**Addendum No. 1**  
**February 17, 2025**

Project: Lincoln High School Auditorium Renovation  
Sioux Falls, South Dakota  
Project #3021

Architect: Architecture Incorporated

**OVERALL FLOOR PLAN - ELECTRICAL**

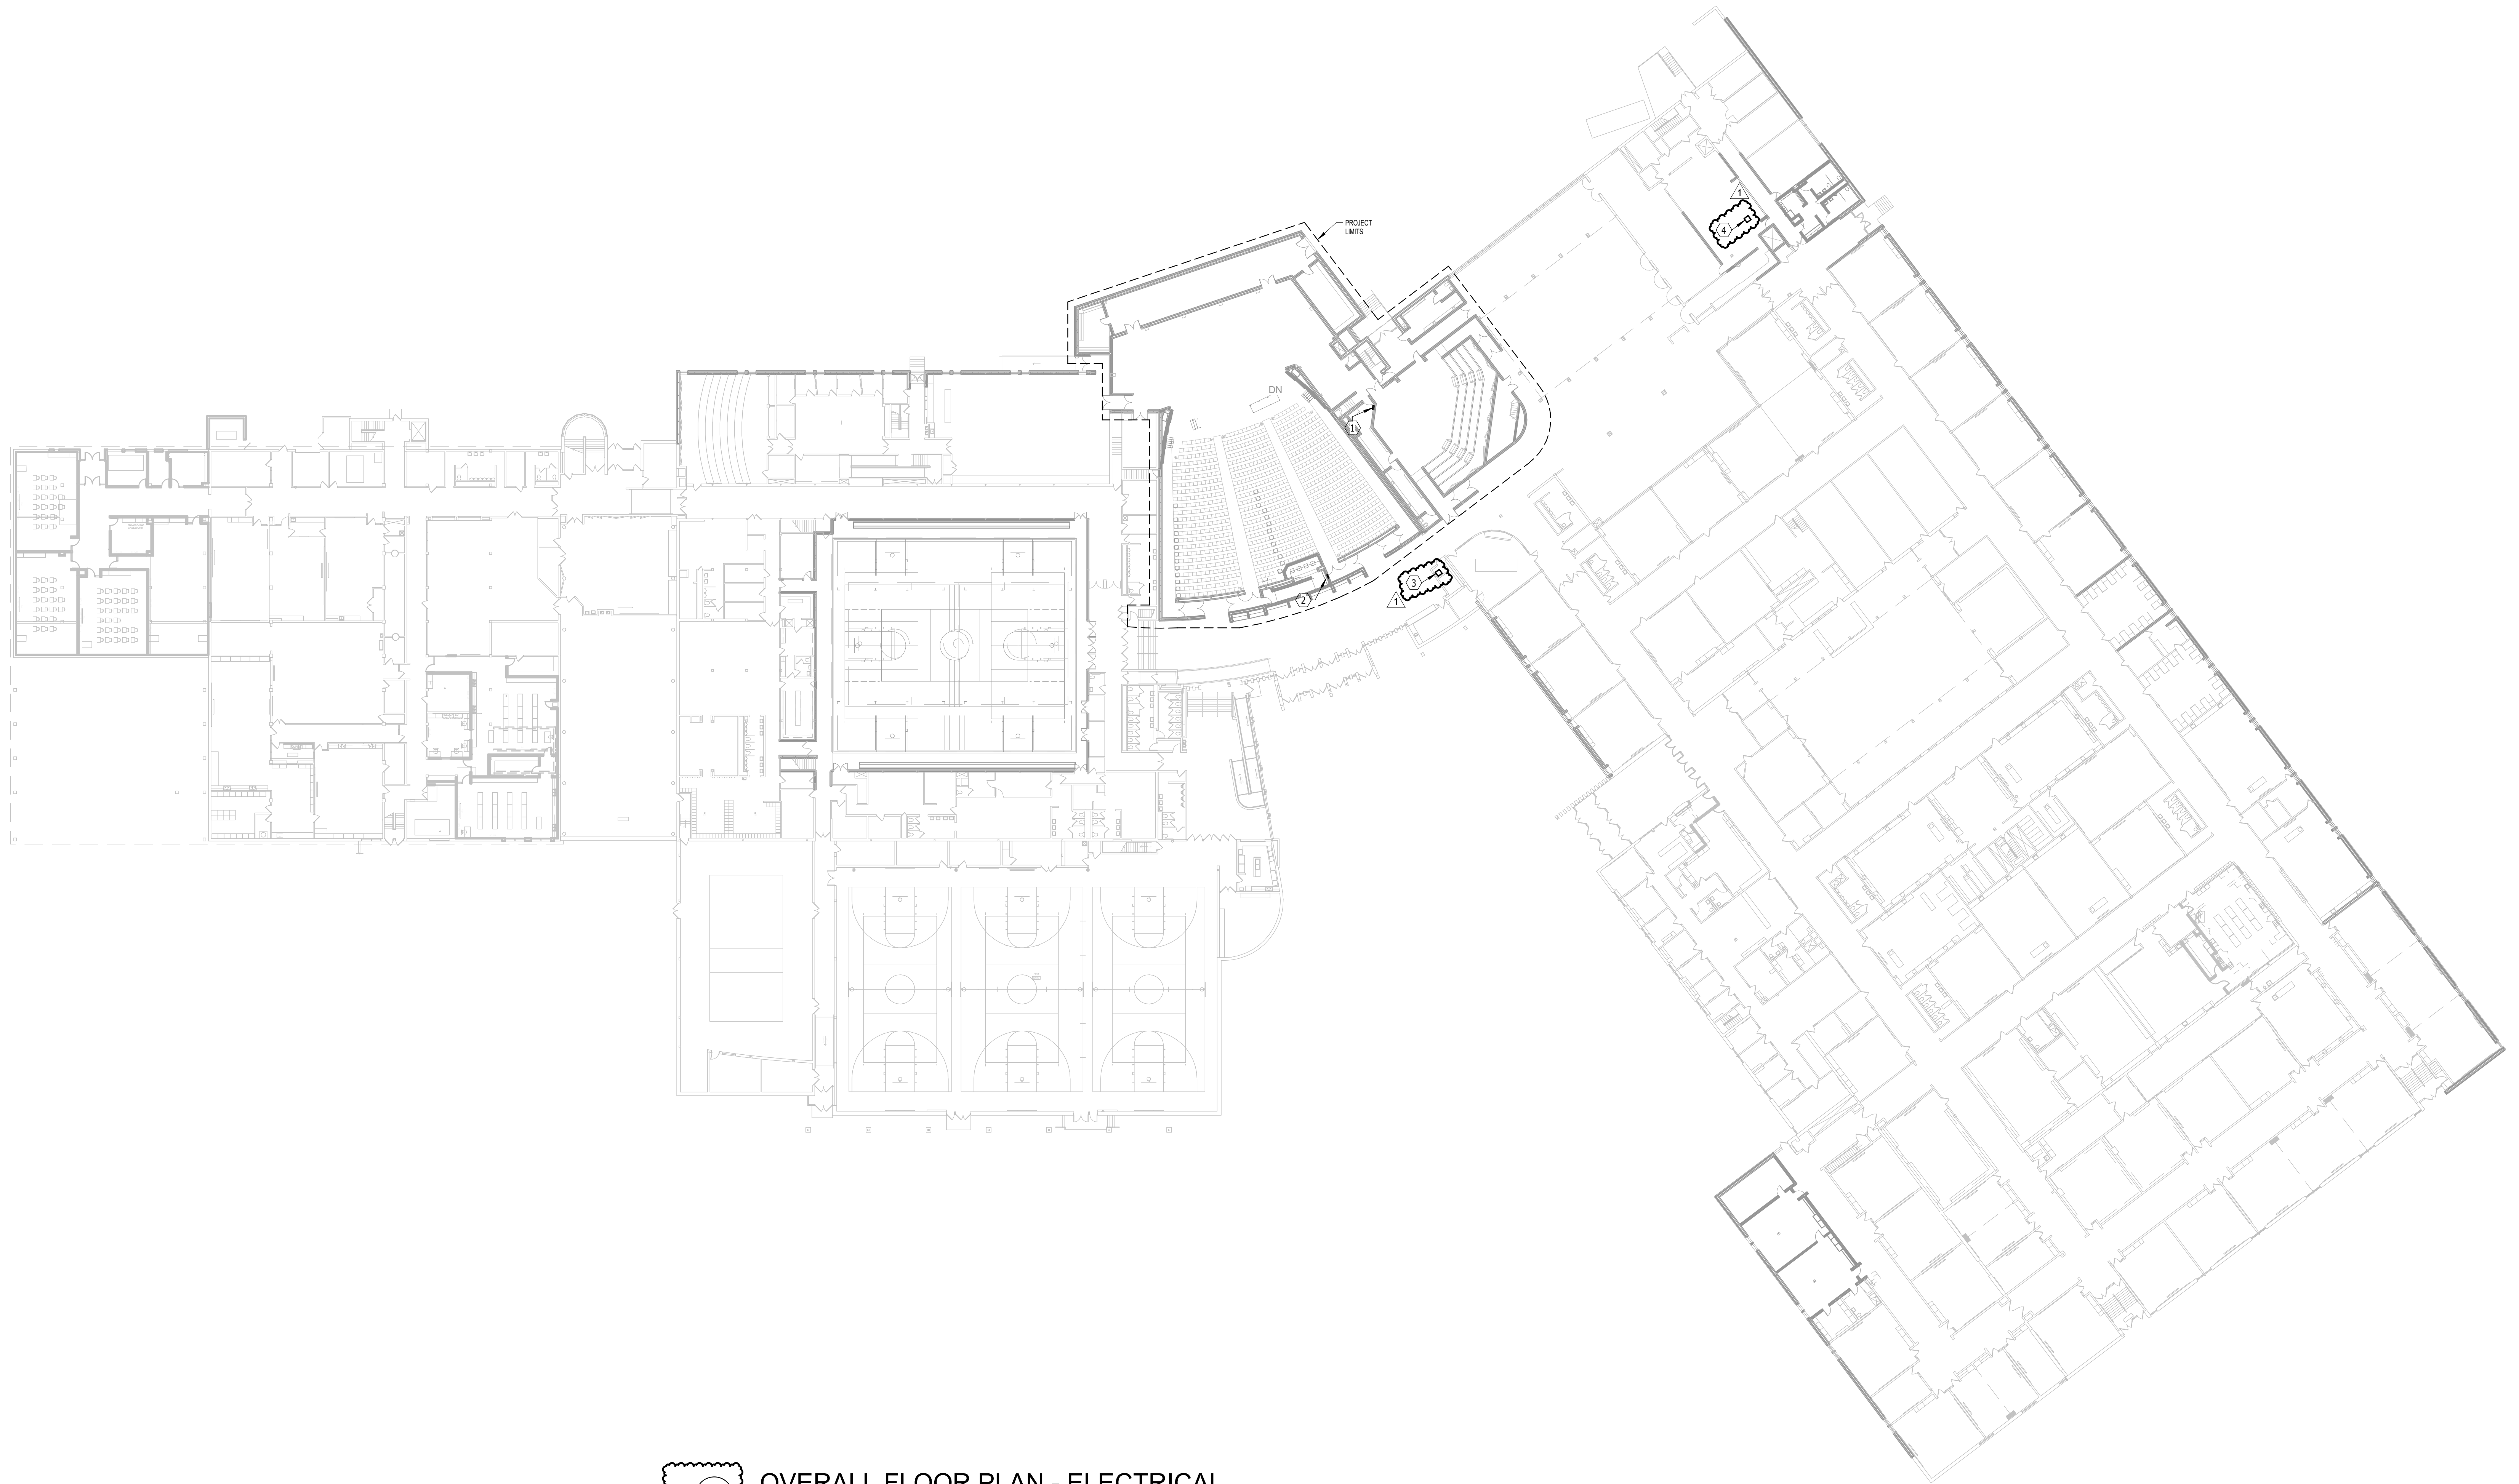
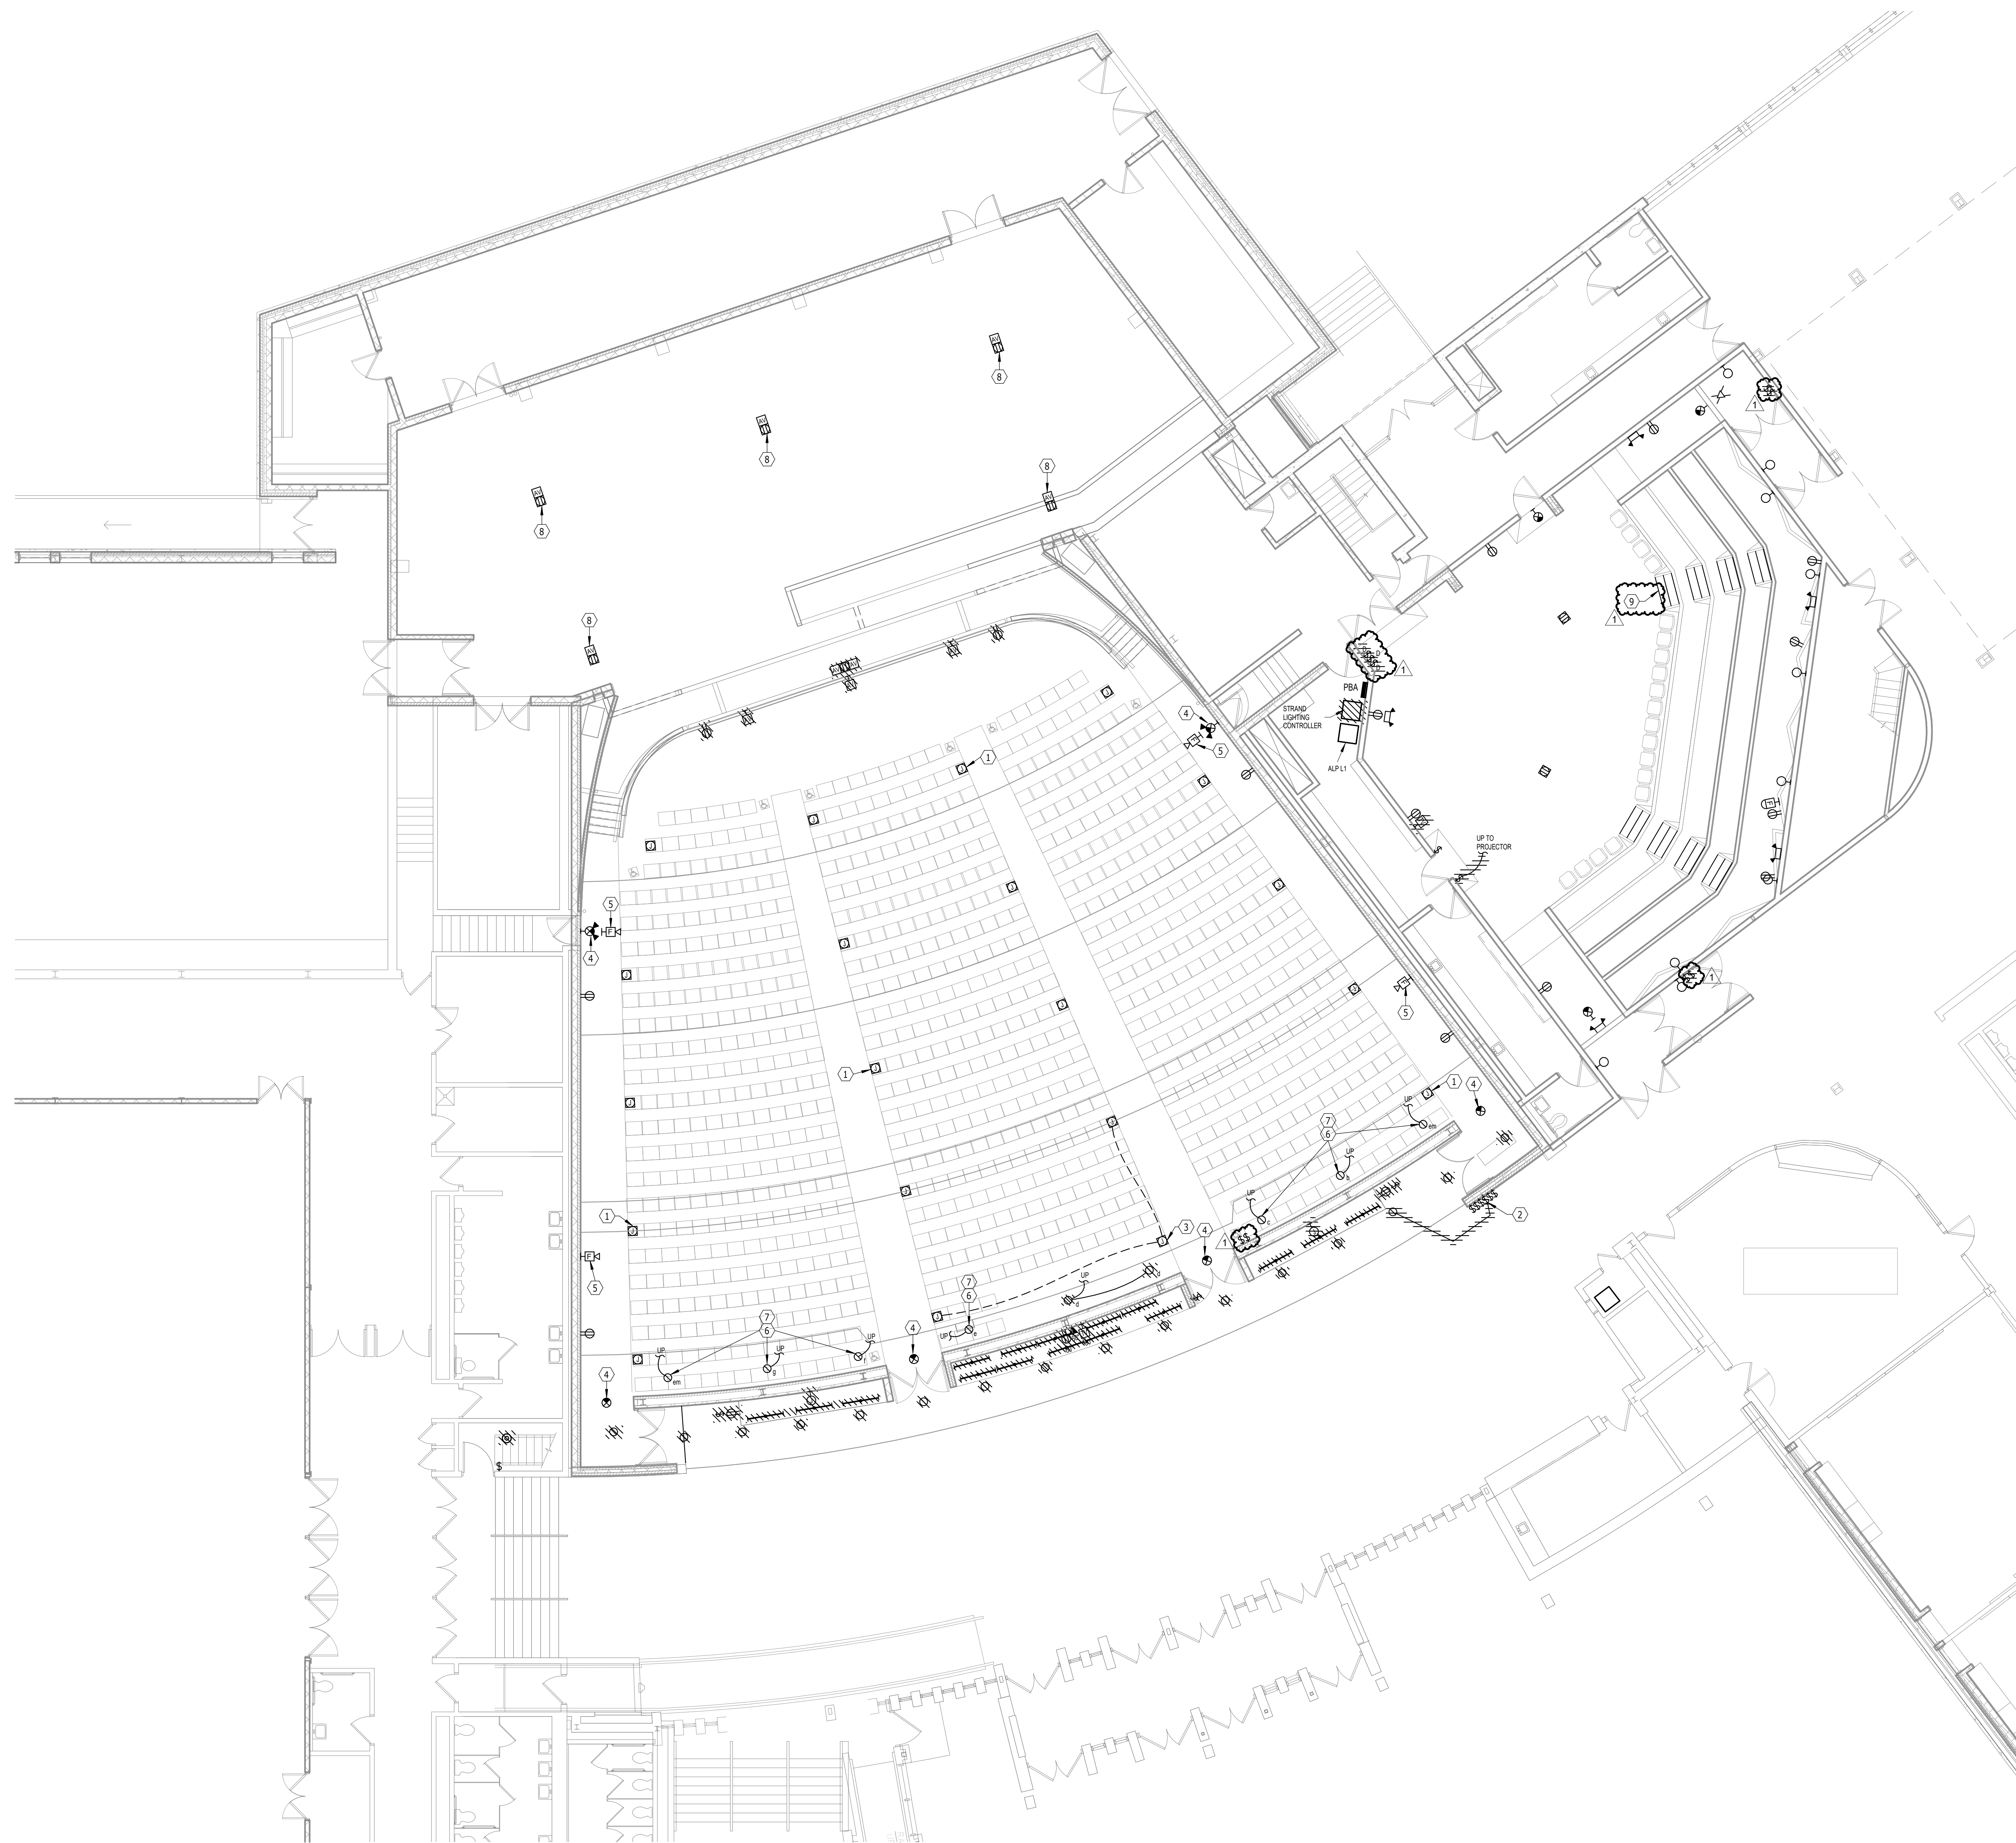
- 1) SHEET 9.10 – OVERALL FLOOR PLAN – ELECTRICAL
  - a) Reference the attached drawing sheet, revision dated 2-17-25, for miscellaneous modifications.
- 2) SHEET 9.21 – FIRST FLOOR DEMOLITION PLAN – ELECTRICAL

**LINCOLN HIGH SCHOOL AUDITORIUM RENOVATION**  
**FIRST FLOOR PLAN - LIGHTING**

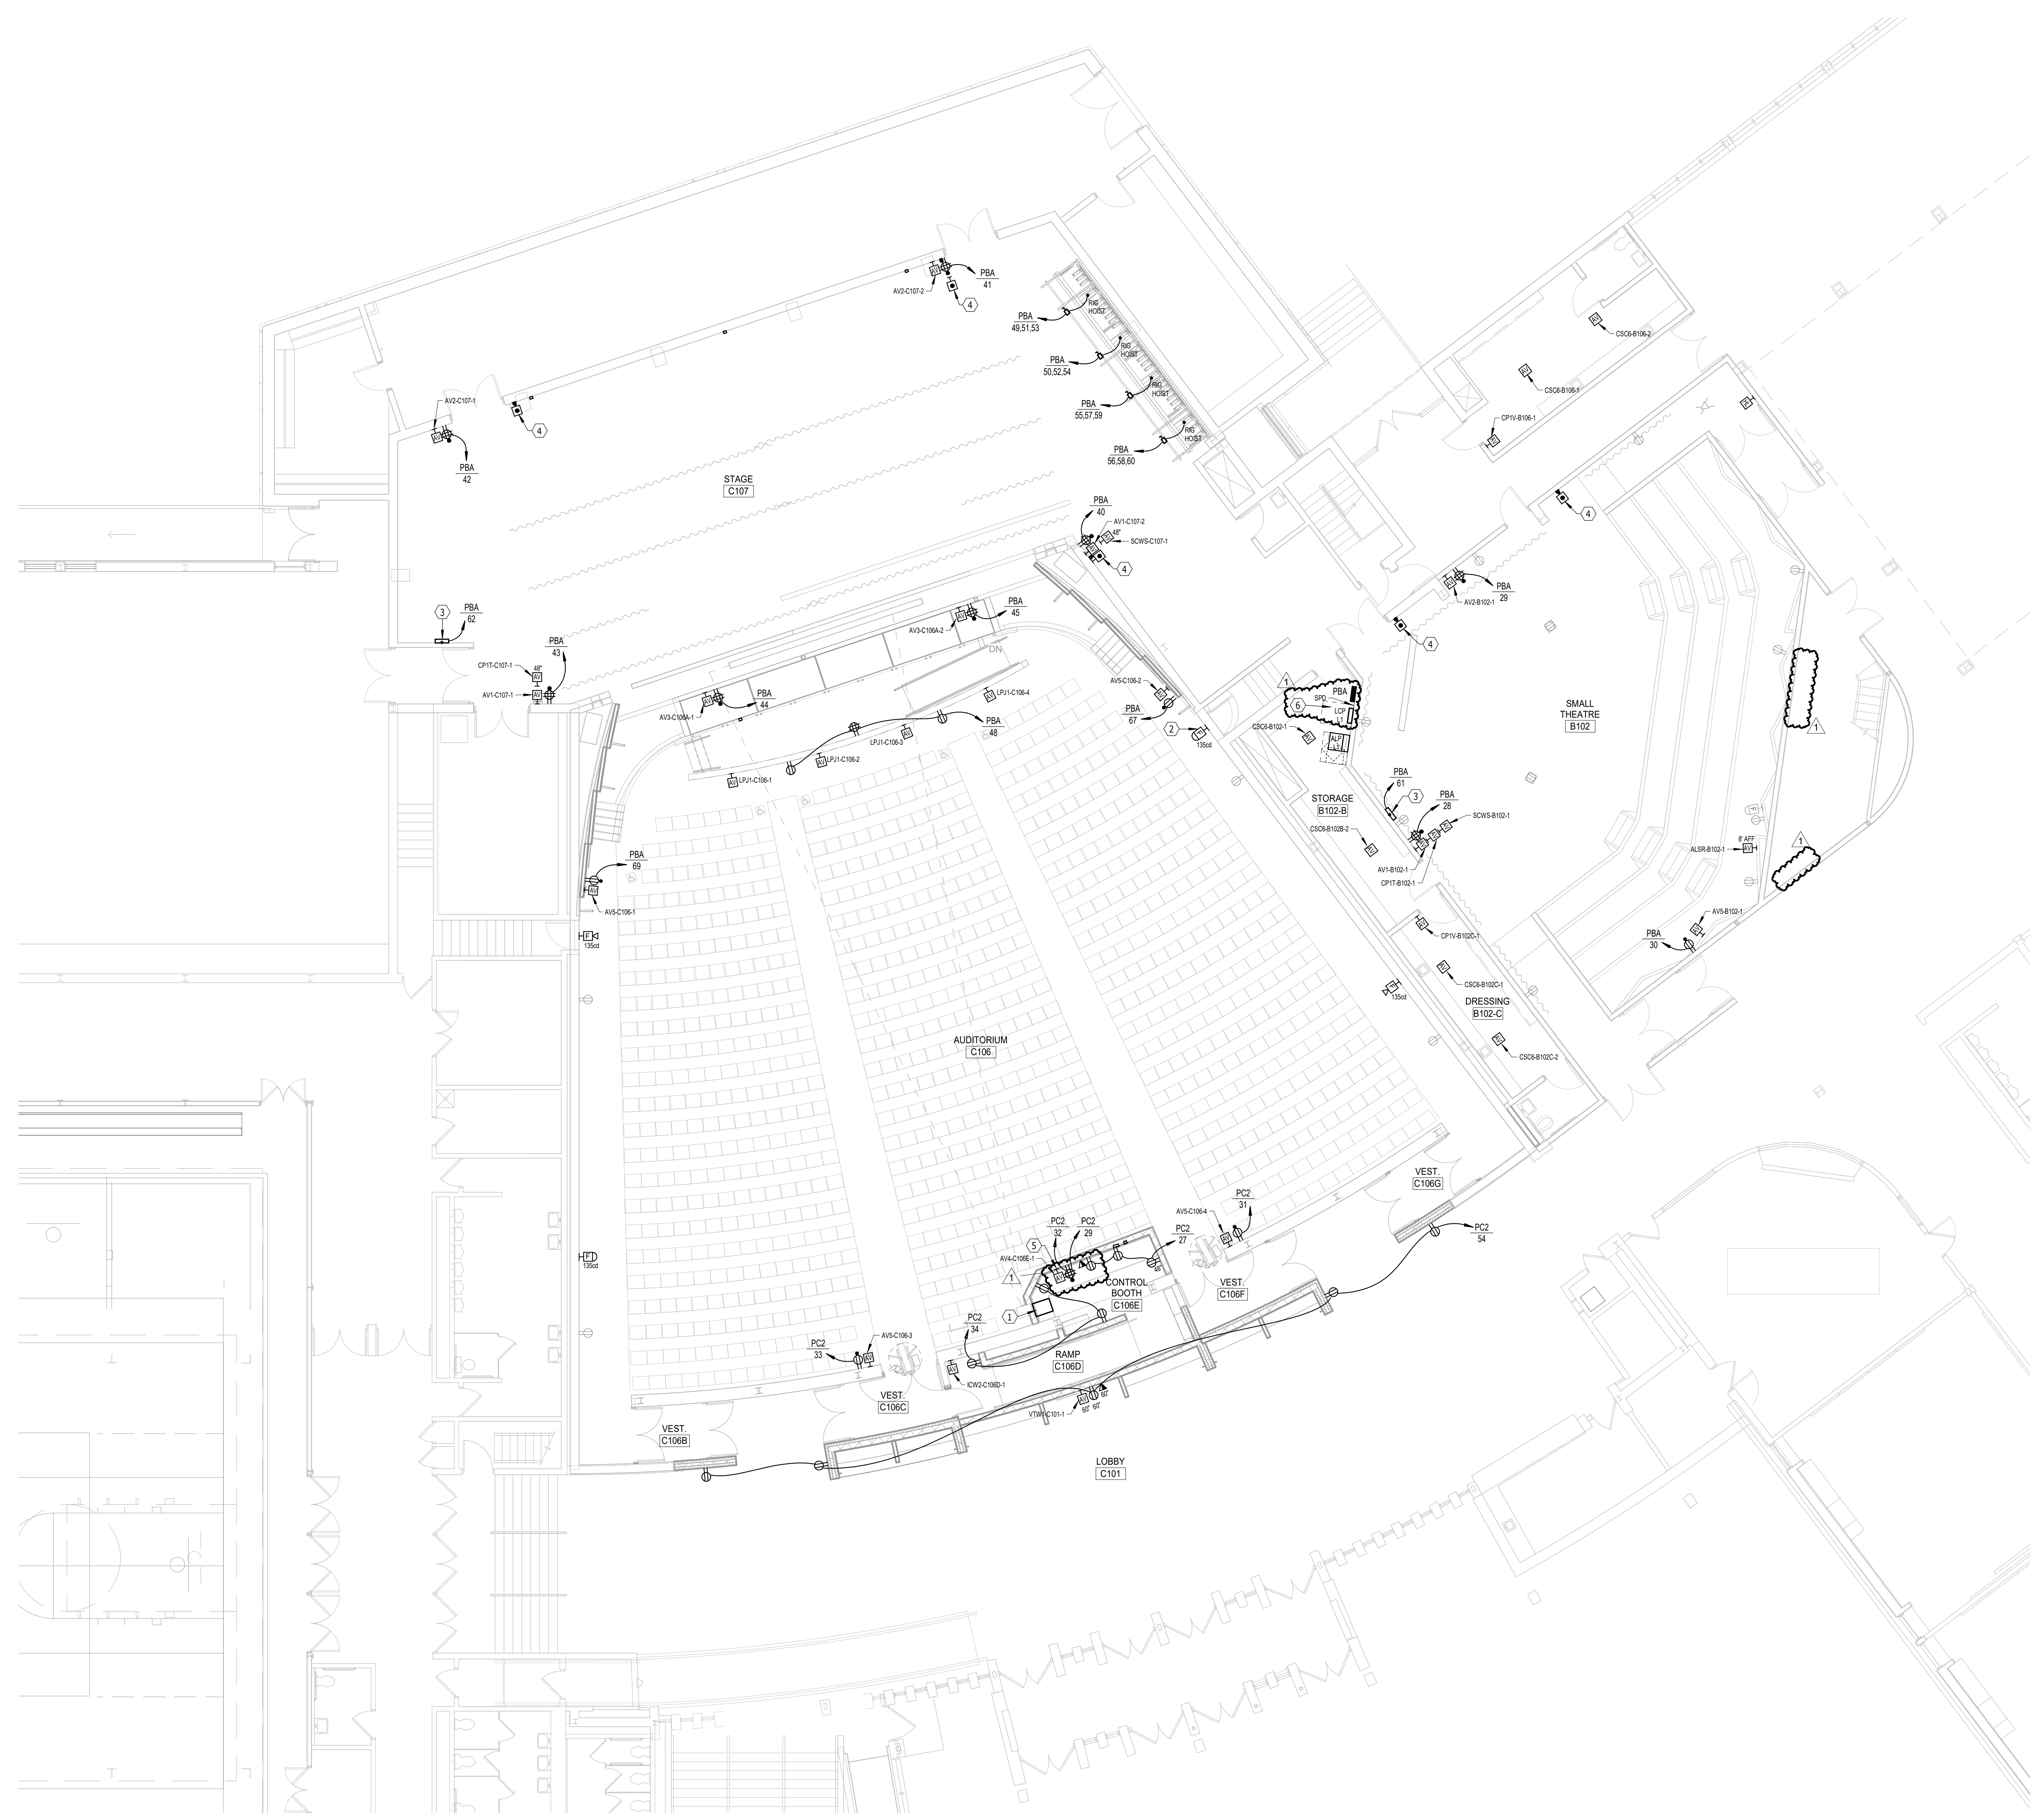
- a) Reference the attached drawing sheet, revision dated 2-17-25, for miscellaneous modifications.
- 4) SHEET 9.30 – FIRST FLOOR PLAN – LIGHTING
  - a) Reference the attached drawing sheet, revision dated 2-17-25, for miscellaneous modifications.
